GENERAL ELECTRIC
FUEL SWELL AND RUPTURE MODEL
EXPERIMENTAL DATA REVIEW
AND
SENSITIVITY STUDIES

May 12, 1981

FIGURE 1

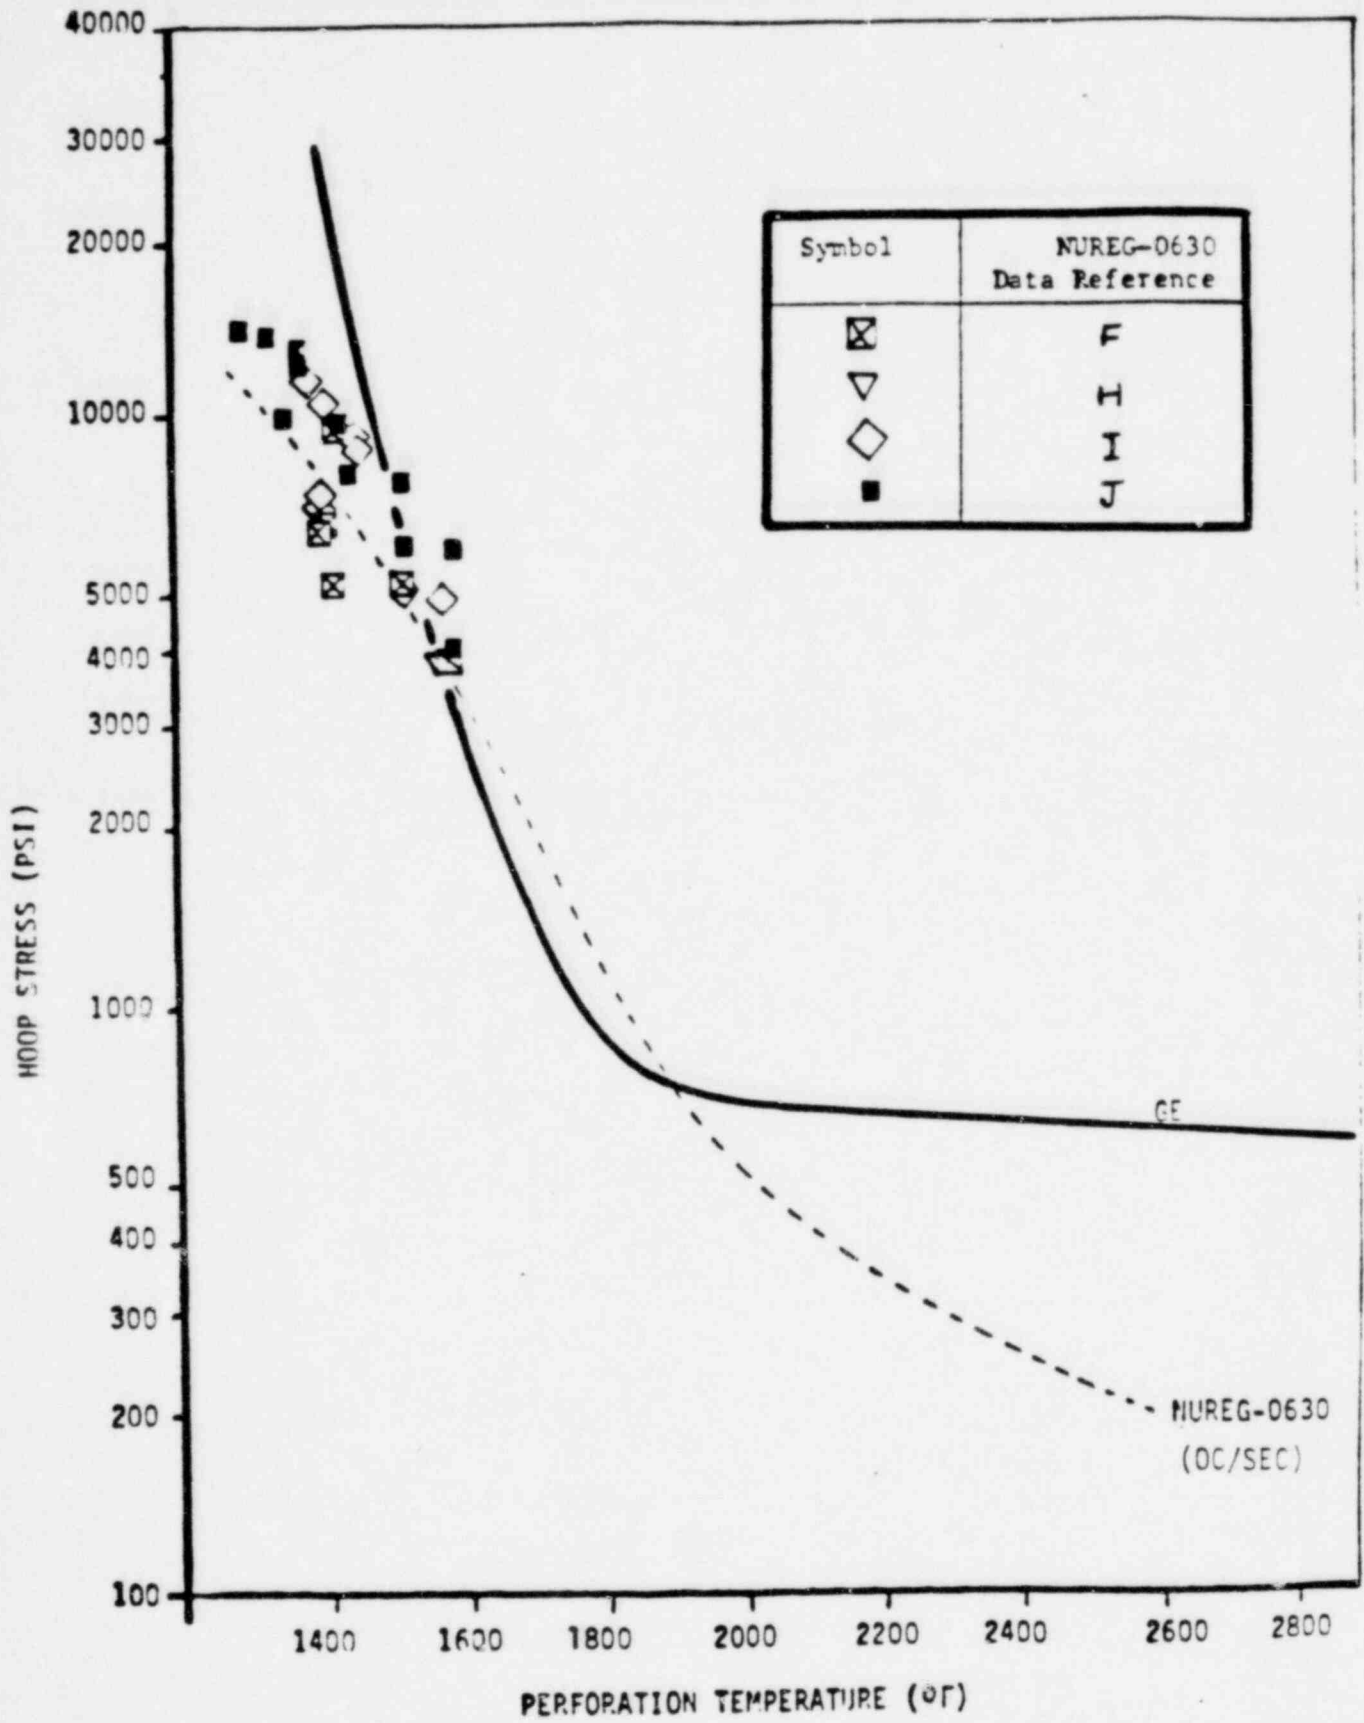
Figure 1 shows the General Electric perforation curve together with the corresponding experimental data base for cladding heatup rates of $\leq 10^{\circ}\text{F}/\text{sec}$. ($10^{\circ}\text{F}/\text{sec}$ is considered a conservative upper bound heatup rate for GE BWR's.) The figure shows that the GE curve is a good representation of the data. Figure 2 shows the NUREG-0630 correlation for $0^{\circ}\text{F}/\text{sec}$ and the GE curve together with NUREG-0630 data for heatup rates of less than $10^{\circ}\text{F}/\text{sec}$.

The following points are apparent from Figures 1 and 2:

- (a) The NUREG-0630 curve contains no data for hoop stresses below ~ 3500 psi and temperatures above $\sim 1600^{\circ}\text{F}$.
- (b) In the temperature range of concern to the staff ($>1832^{\circ}\text{F}$), a considerable amount of data typical to the BWR exists to support the GE curve.

FIGURE 2

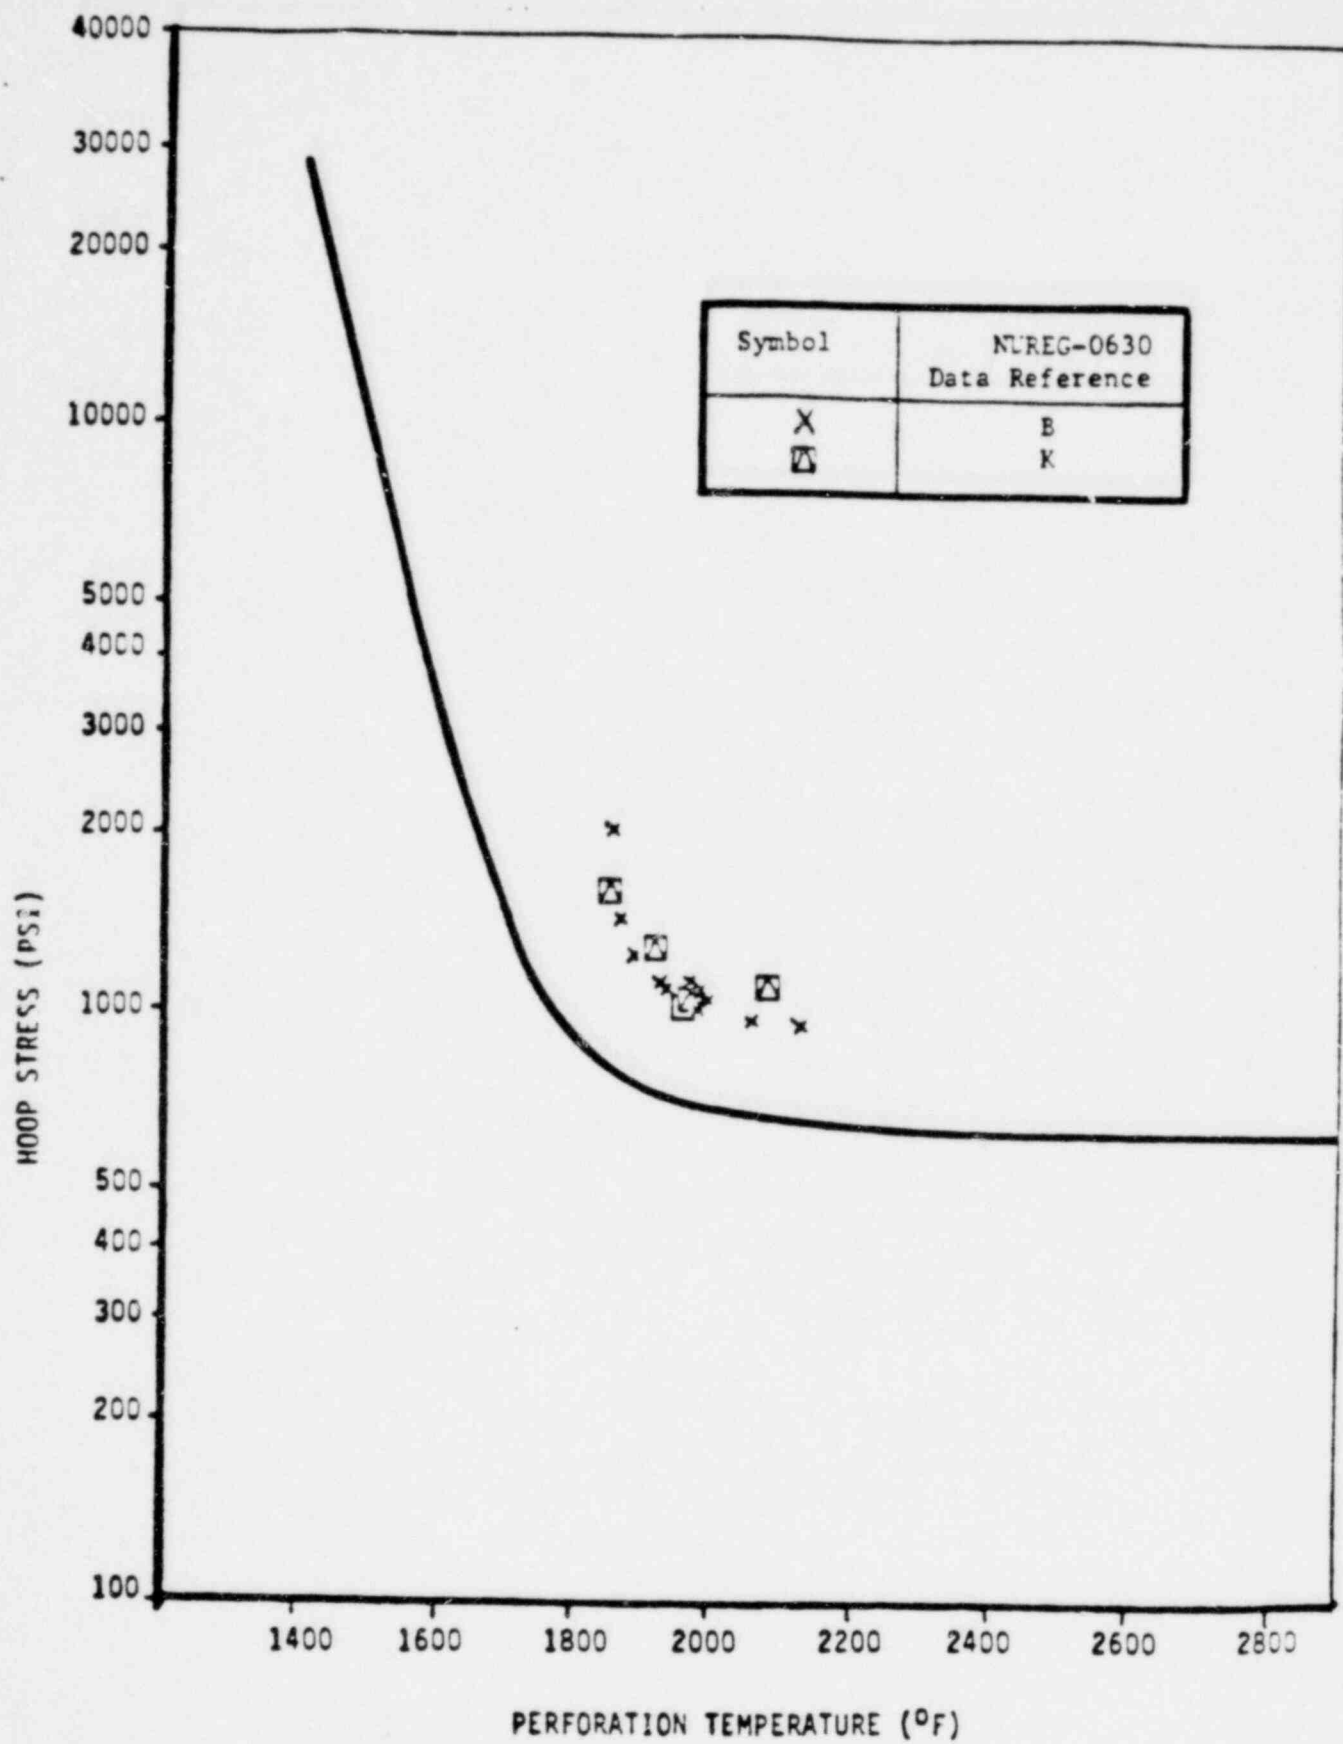
In addition, the recent data generated by KfK (Reference 5) have been examined with respect to the General Electric model. These data, which are shown in Figure 4 indicates that the GE model is conservative with respect to the data for temperatures above $\sim 1600^{\circ}\text{F}$. Figures 2 and 4, however, indicate that the GE design curve may be non-conservative with respect to the data for temperatures below $\sim 1600^{\circ}\text{F}$.

FIGURE 3

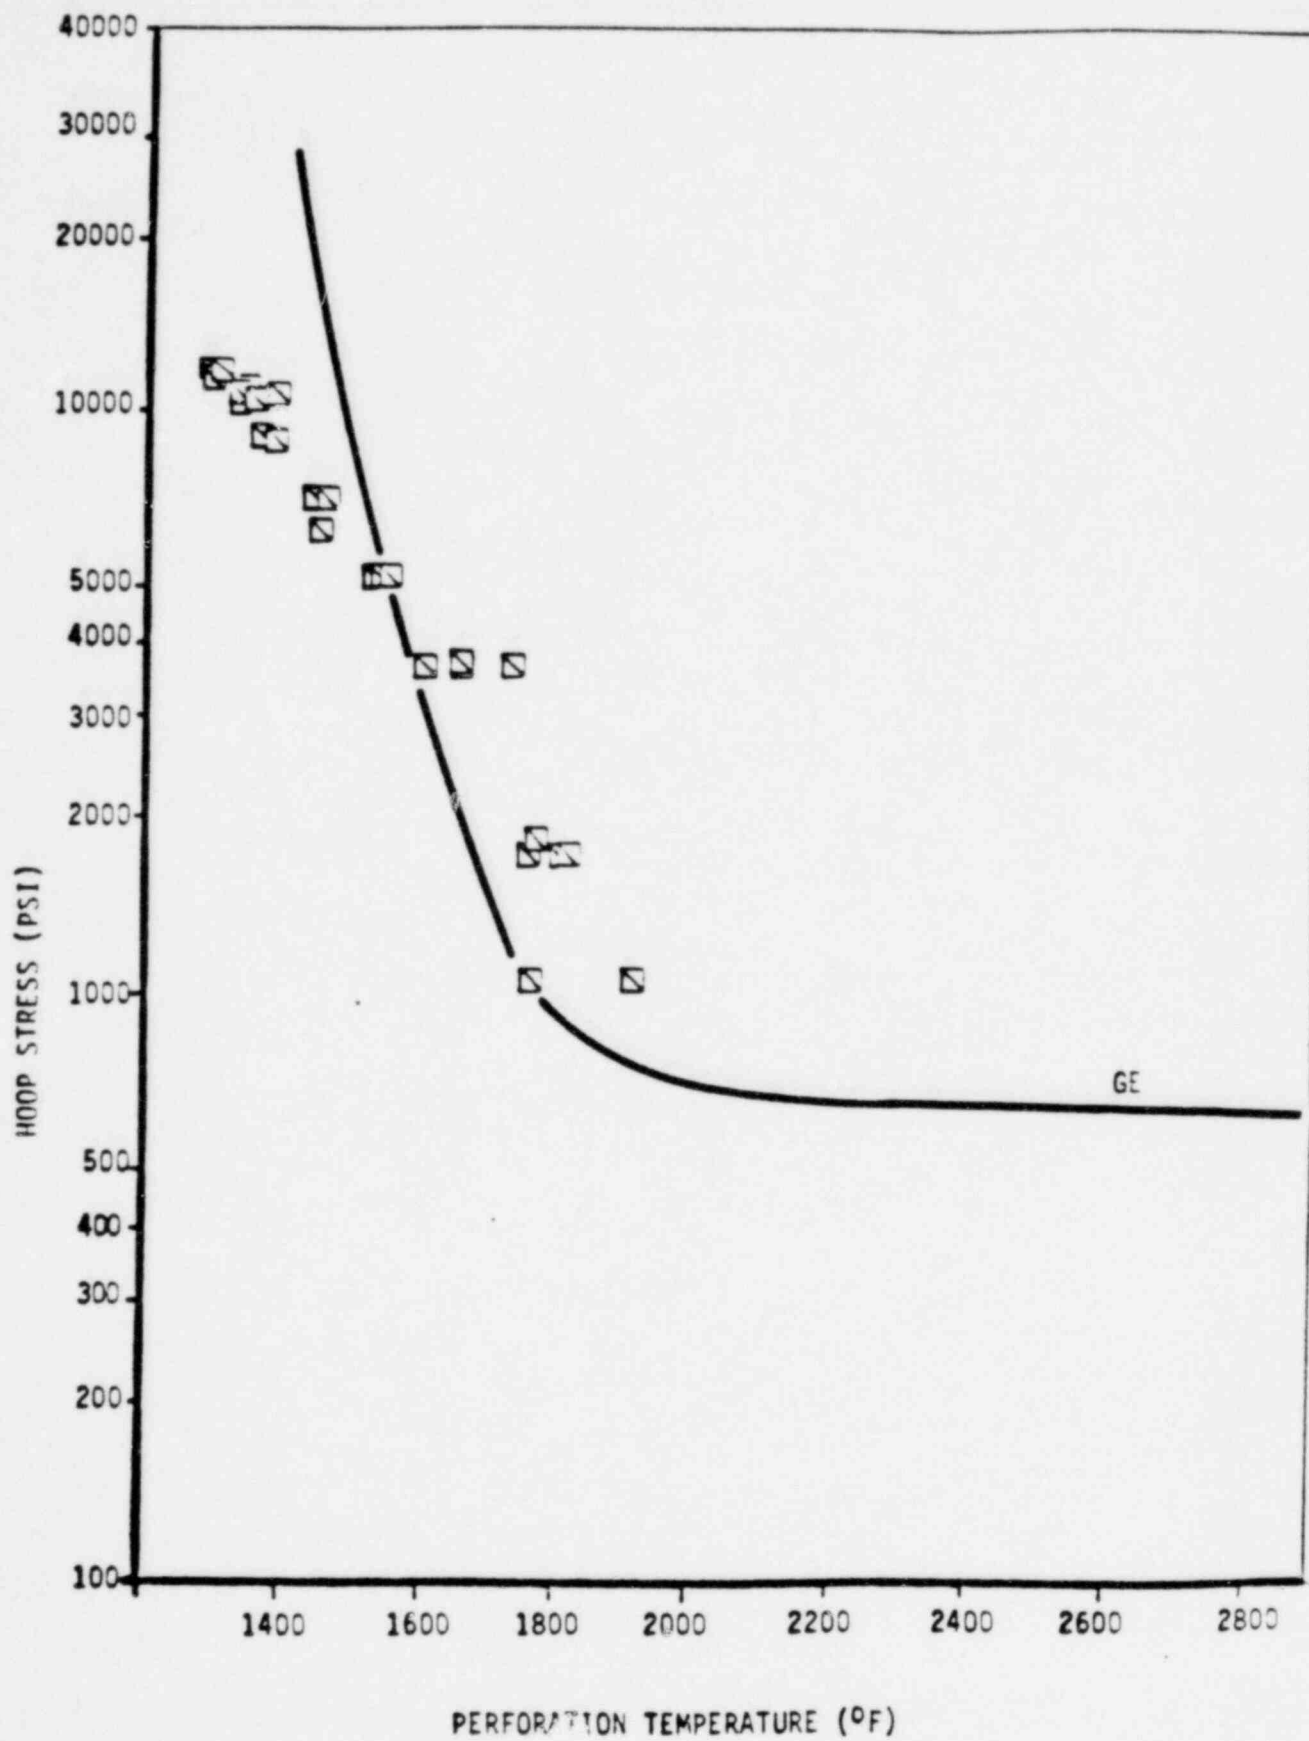
Furthermore, General Electric has examined all data in NUREG-0630 (irrespective of heatup rate) with perforation temperatures above 1832°F (1000°C). These data have been plotted in Figure 3. This figure indicates that the GE curve is conservative with respect to these data.

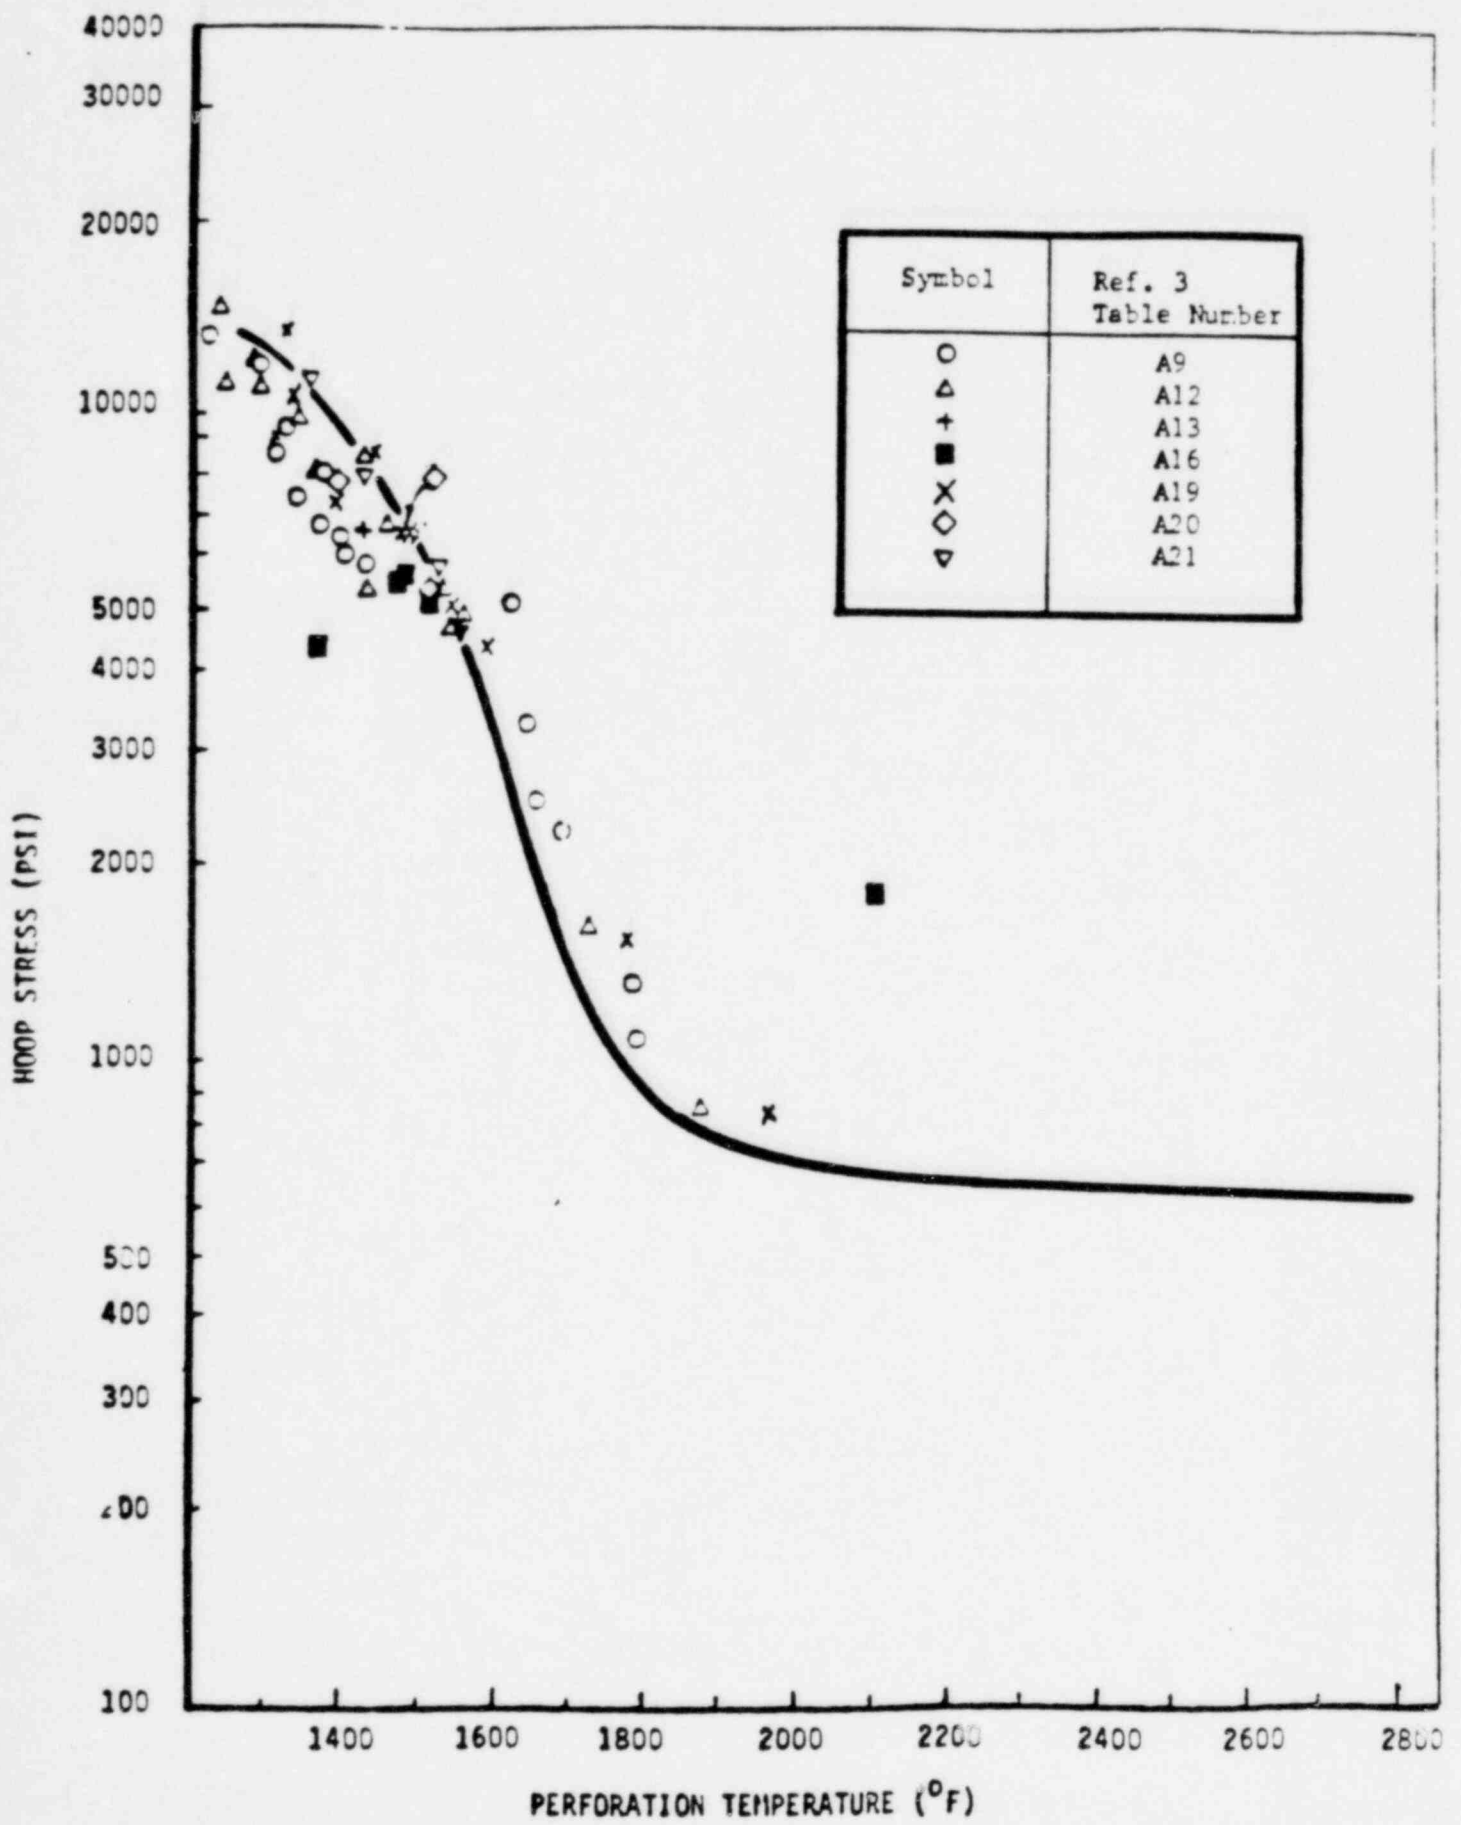
General Electric agrees with the NUREG-0630 data presented in this temperature range. However, the overall effect of revising the GE curve in this range is $< 10^{\circ}\text{F}$ on the PCT. Figure 5 shows the data from Figures 2 and 4 for temperatures below $\sim 1600^{\circ}\text{F}$ together with the GE data base and adjusted curve.

General Electric believes that the adjusted GE hoop stress versus perforation temperature curve (Figure 5) is an accurate representation of BWR fuel behavior for LOCA analysis and that the replacement of this curve with the corresponding $0^{\circ}\text{F}/\text{sec}$ NUREG-0630 is not appropriate.
